STATE OF NORTH CAROLINA  
DEPARTMENT OF TRANSPORTATION

Subject: **Application for Individual Section 404 Permit and Individual Section 401 Certification** for Improvements to the NC 18 (Sterling Street) and I-40 Interchange in Morganton, Burke County, NC (TIP No. U-2550B, State Project No. 8.1851001, Federal Aid Project No. M-8165(1)).  
T.I.P. Project U-2550B  
Debit \$570.00 from WBS Element 34831.2.4

**Final Minutes for Permit Drawing Review Meeting  
U-2550B  
Morganton- NC18 and I-40 Interchange**

**Final Minutes for Second Permit Drawing Review Meeting  
U-2550B  
Morganton- NC18 and I-40 Interchange**

# Site 3 (partial) Enlargement

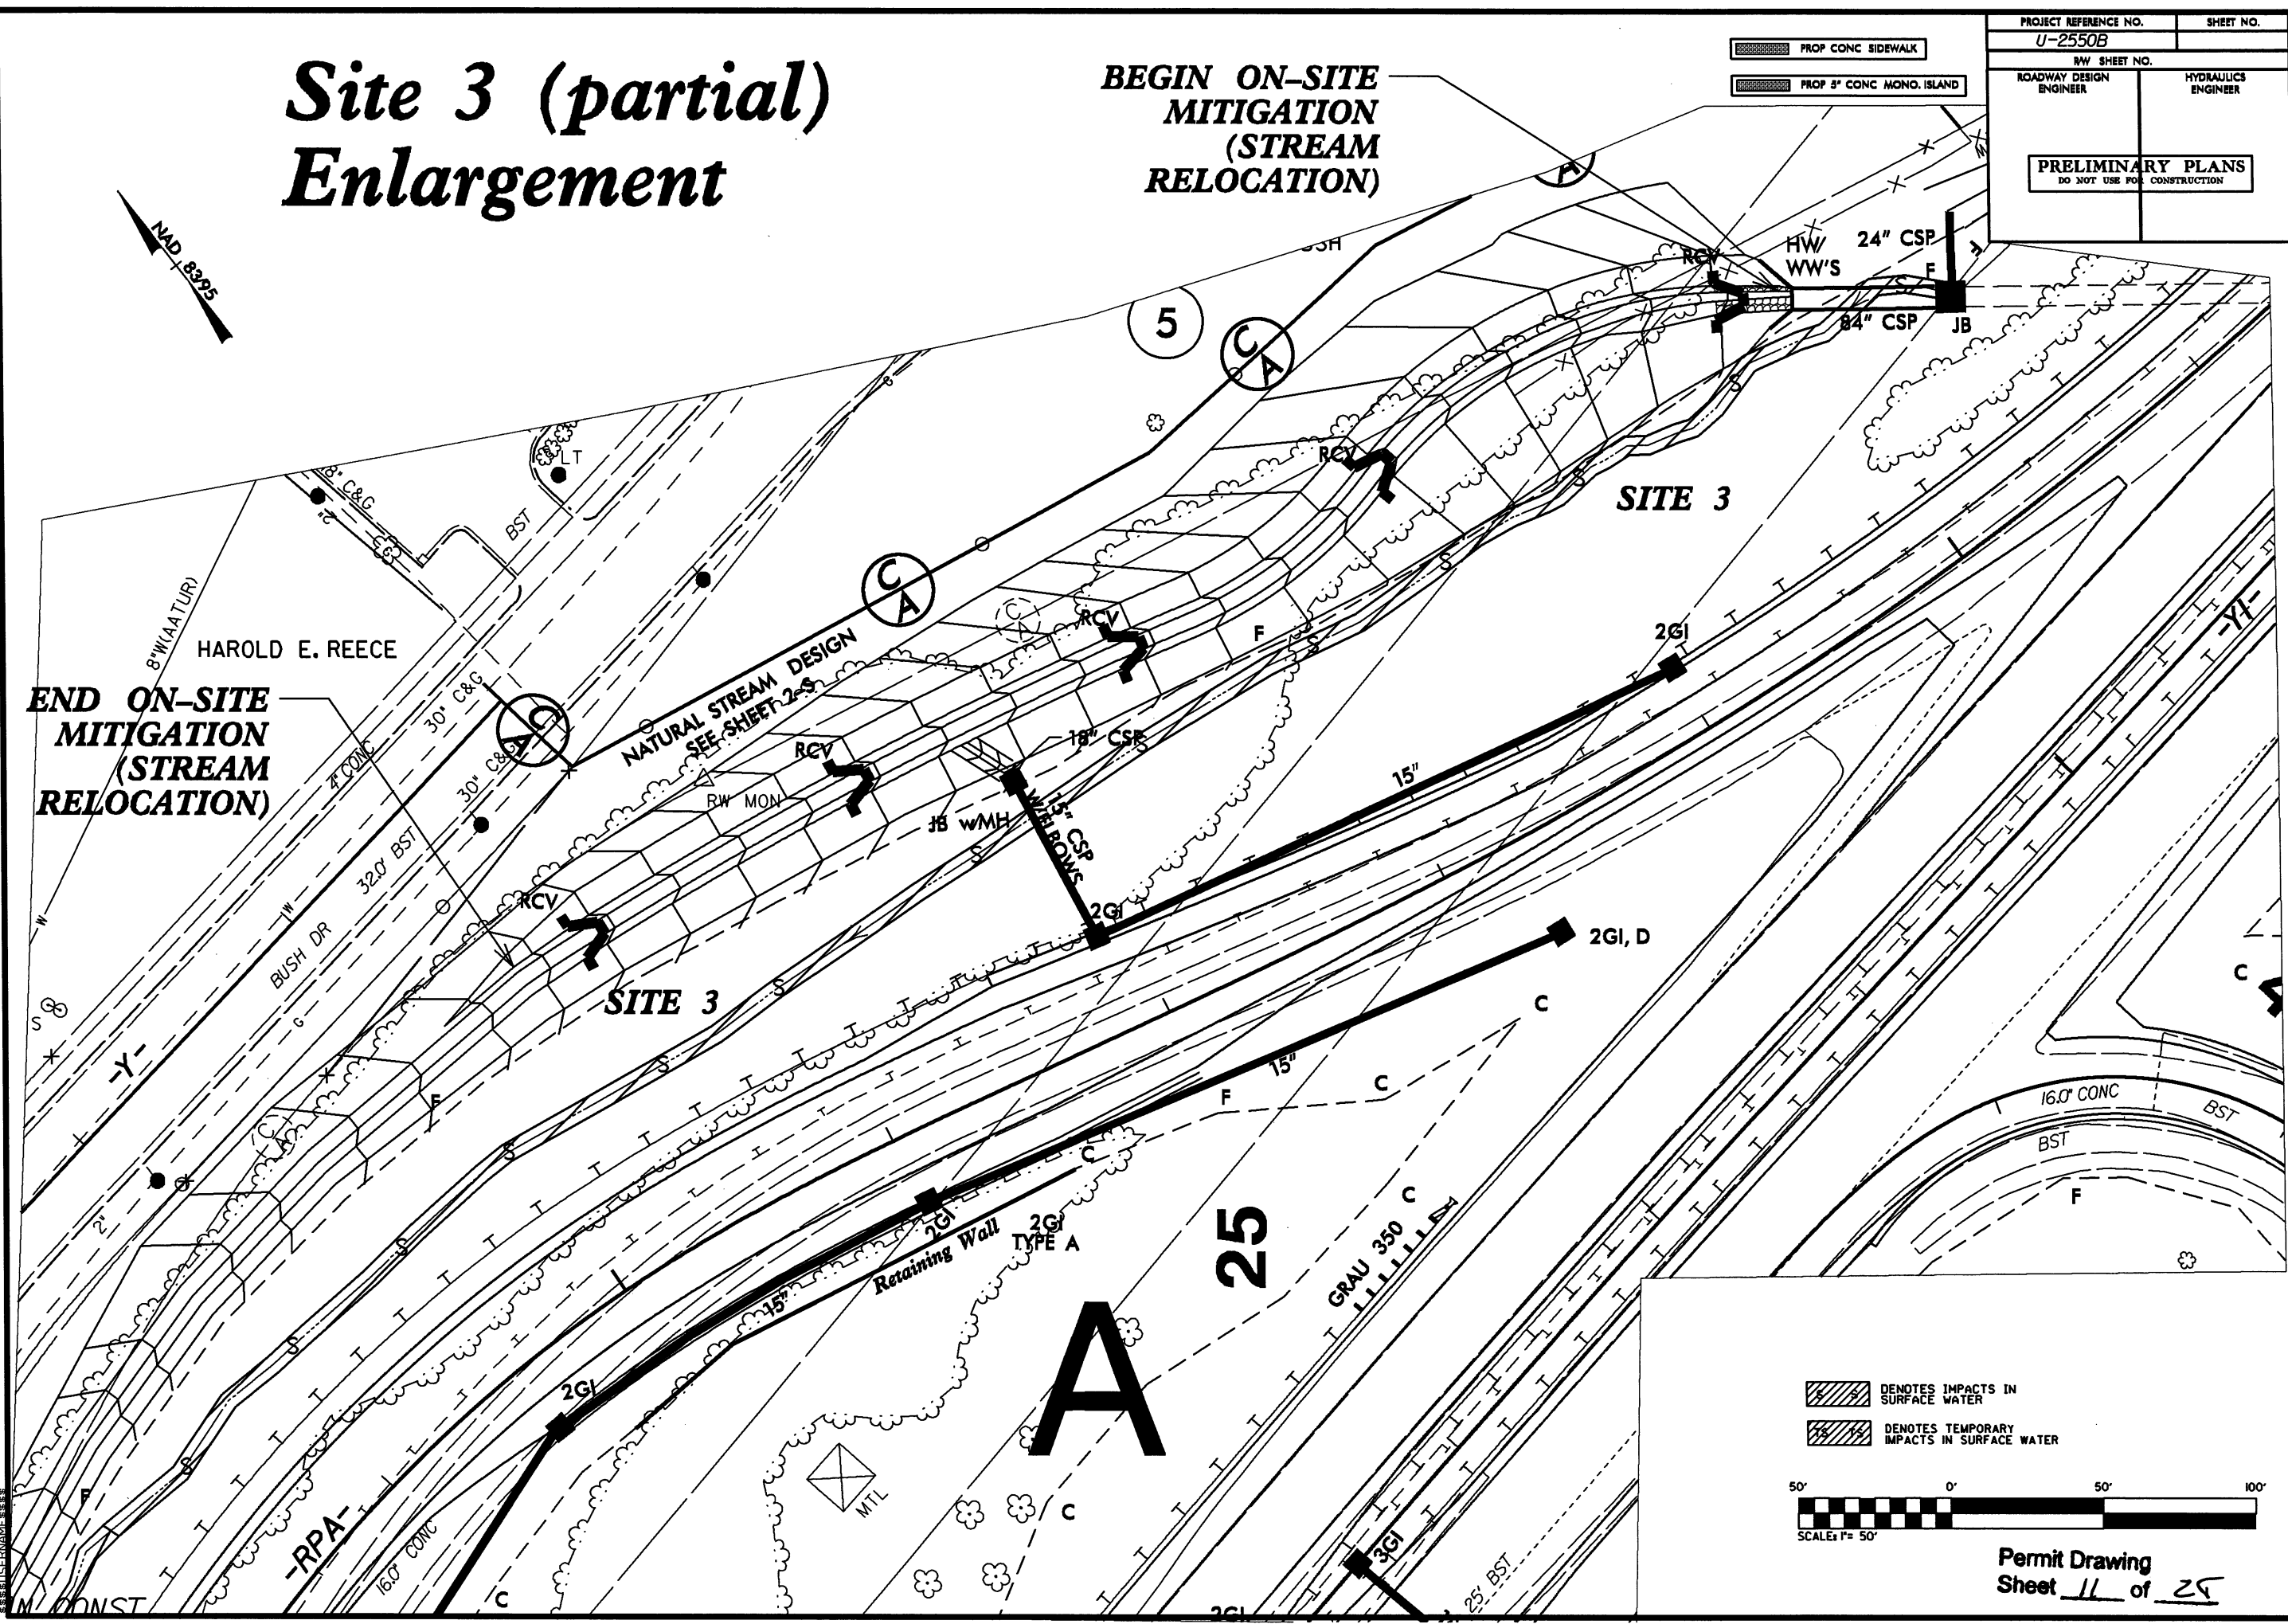
The group then discussed the natural stream design for site 3. NCDOT indicated the latest design shows a minimum of a 30' vegetated buffer around the stream that will be contained in controlled-access right-of-way. The species selection for reforestation will be sensitive to site conditions; smaller tree and shrub species may be planted along the slopes and areas where visibility may be a concern. For roadside maintenance, NCDOT will only mow a small strip along the ramp which would be outside the 30' buffer. The group discussed the outlet stability of the 15" pipe at site 3 and decided to revise the outlet to provide better energy dissipation. NCDOT said this would likely be accomplished with a junction box and larger pipe outlet that can be partially buried and laid at a flat slope. The rip rap pad would be retained for bank protection. The group discussed the stream design parameters, noting that the stream cross section will be a more stable section than the existing stream section. With the increased buffers and natural stream design, DWQ indicated full mitigation credit would be allowed for site 3.

**Site 3** involves the relocation of an unnamed tributary to the East Prong of Hunting Creek. NCDOT said the rip rap shown in the stream was on the banks only and was needed where the stream benches narrowed below 10' where the ramp was realigned from the previous design. NCDOT asked if the mitigation ratio would be 1:1. COE said the ratio for mitigation would be a 1:1 ratio. (Note the previous 4C minutes show a 1:1 was agreed upon). NCWRC asked if the tail ditch from the pipe outlet approximately mid-way of the stream relocation could be aligned in a more down-stream angle. NCDOT said it could be, and would realign the tail ditch. COE asked about the limits of the rip rap. NCDOT explained that the rip rap was shown in the area that will not be receiving mitigation credits. NCWRC asked if the stream design is the same. NCDOT said the design is the same, just slightly shifted to follow the new ramp alignment, and the floodplain bench had to be reduced through the armored section where the ramp is closest to the service road. NCWRC asked if the stream joins the culvert downstream. NCDOT said it does, and an overflow pipe will be added at a higher elevation than the stream grade to convey larger flood events directly into the new section of the culvert under NC18. COE asked what the length of the portion of the stream relocation that did not have 30 ft buffers was at Site 3. NCDOT noted this length was approximately 265 ft.

# Sites 5, 6, & 7 Enlargement

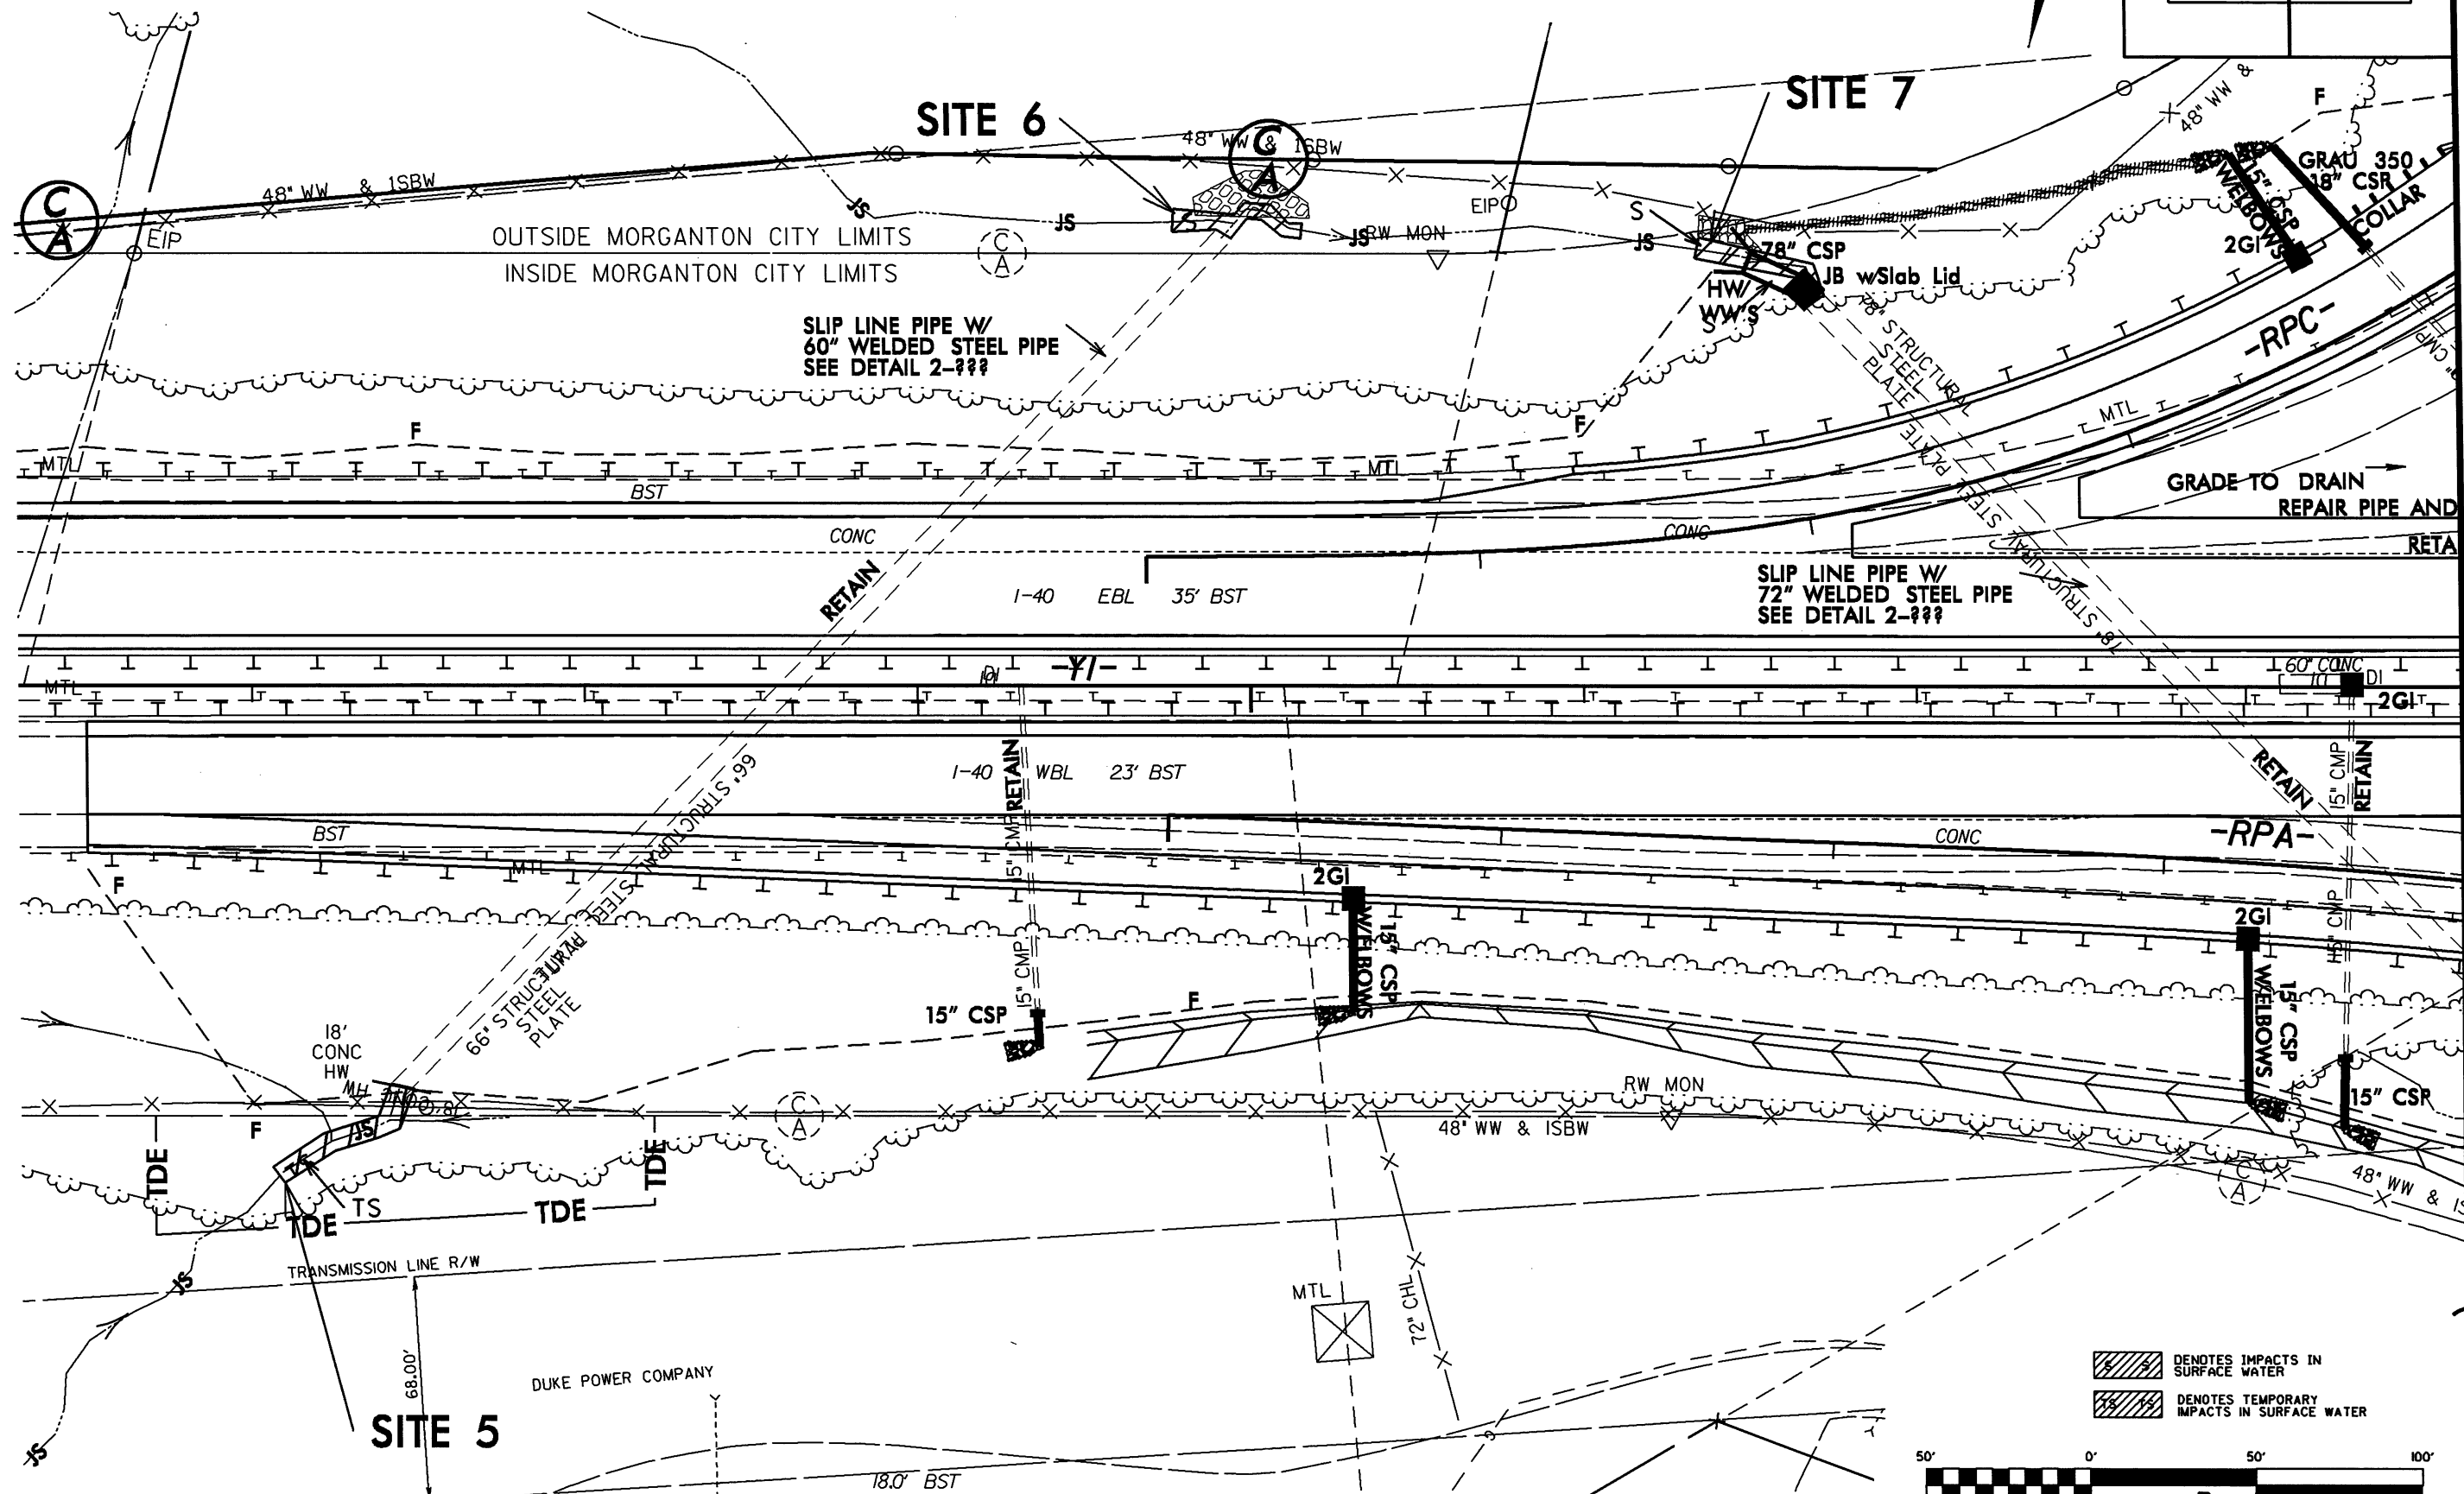
NCDOT will revise the topography at site 5 to show that the jurisdiction stream actually connects to the entrance of the 66" pipe. NCWRC inquired if the pipe outlet at site 6 is stable. NCDOT will investigate if bank protection measures are warranted. The group discussed if additional armoring was needed at site 7, and agreed it was. NCDOT will add additional bank protection at the 78" pipe entrance and Ramp C ditch outlet.

The change at **Site 6** was the addition of bank stabilization as requested by the group at the previous permit drawing review meeting.

The change at **Site 7** was the addition of bank stabilization as requested by the group at the previous permit drawing review meeting.
